Section 96(1A) Modification Application (SSD 7173) – Mamre Road, Orchard Hills,

Section 96(1A) – SSD 7173

Warehouse and Distribution Centre
585-649 Mamre Road Orchard Hills

Figure 2: Proposed Layout, Lot 8A (Linfox)

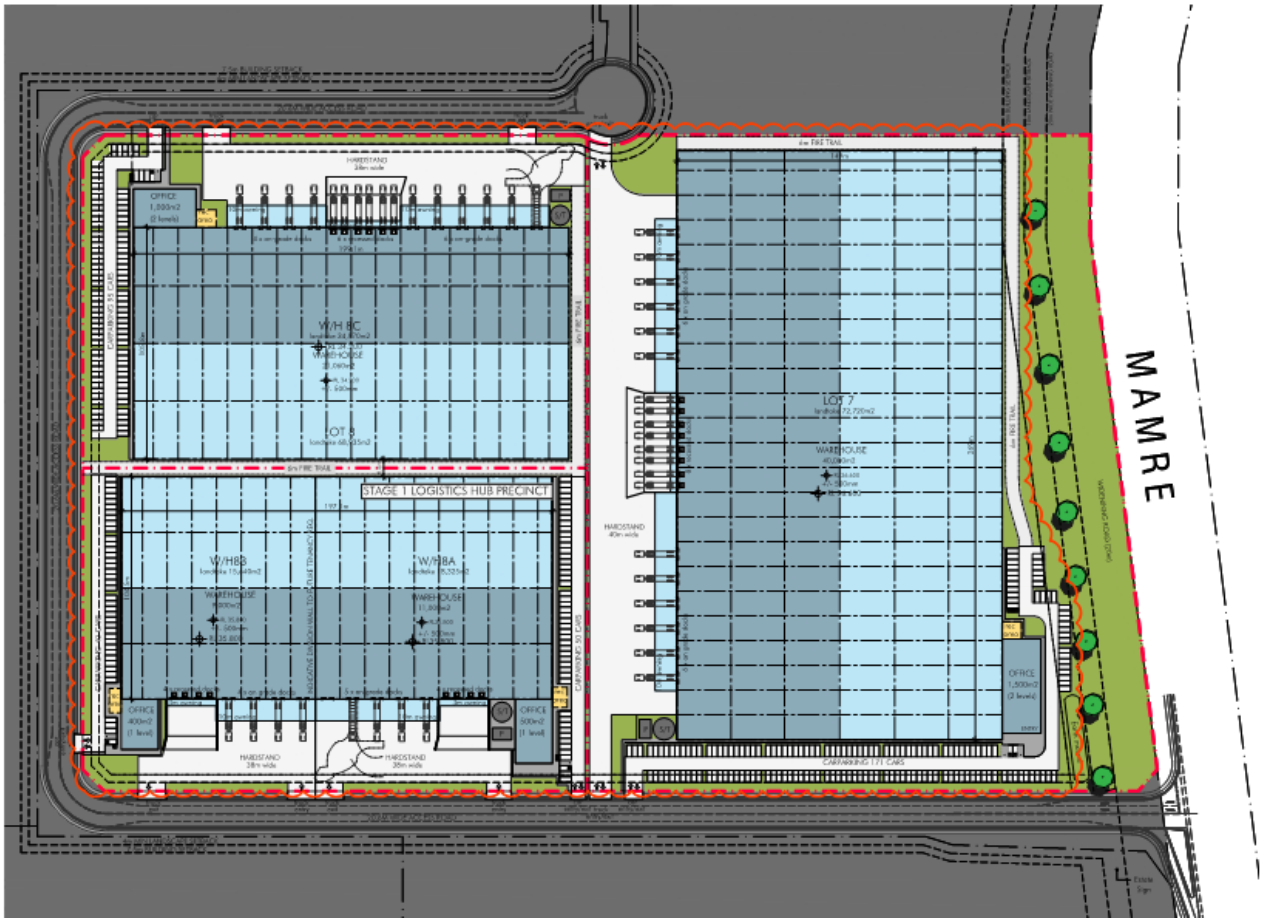
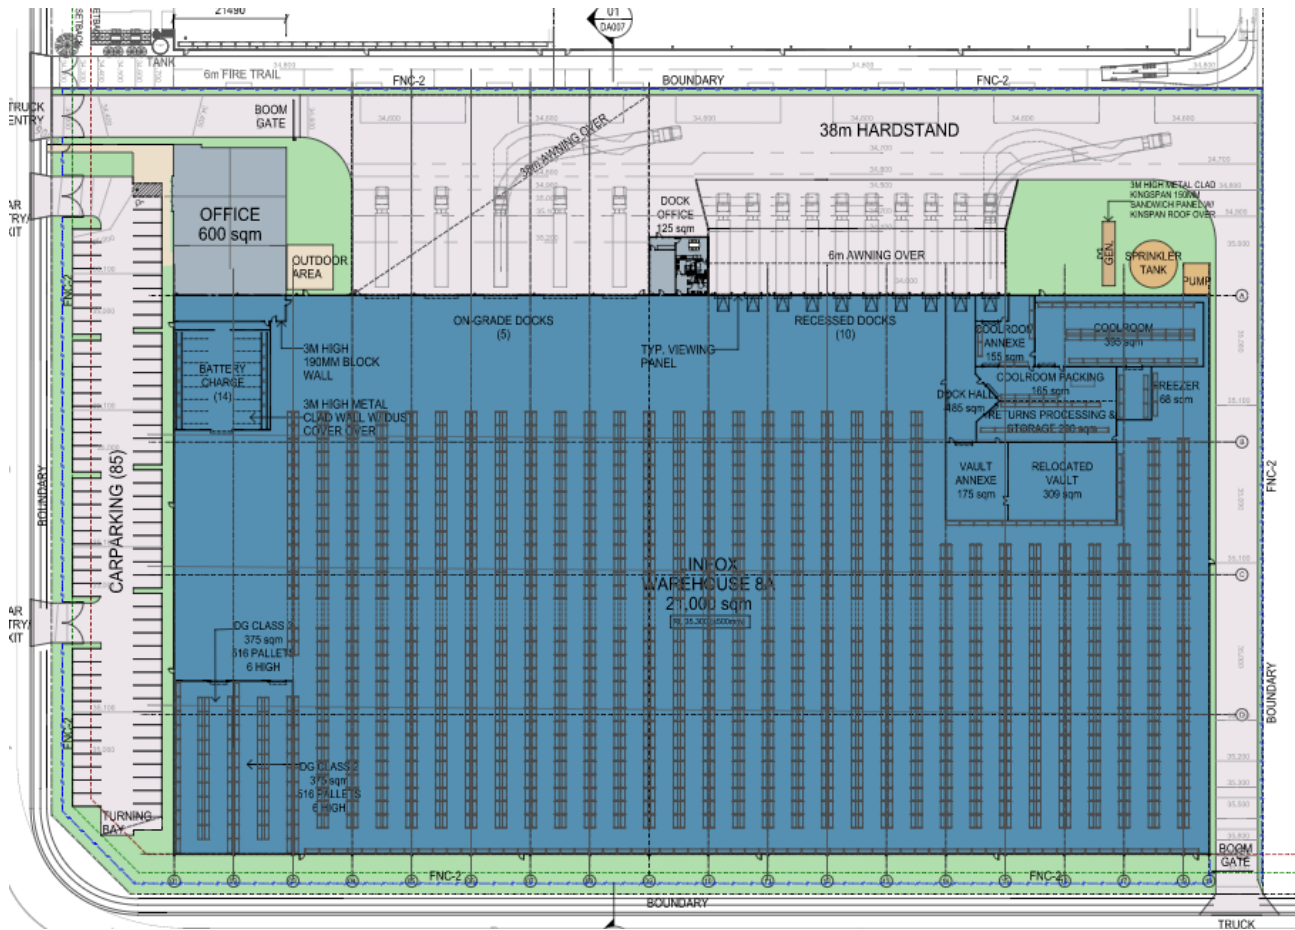
Table 2 below demonstrates the proposed modifications against the approved SSDA 7173. As evident, the modifications are minimal and do not differ substantially from originally approved.

Further, it is proposed Lot 8 be subdivided into two lots. This is to allow the two buildings to be viewed as standalone from an economics point of view.
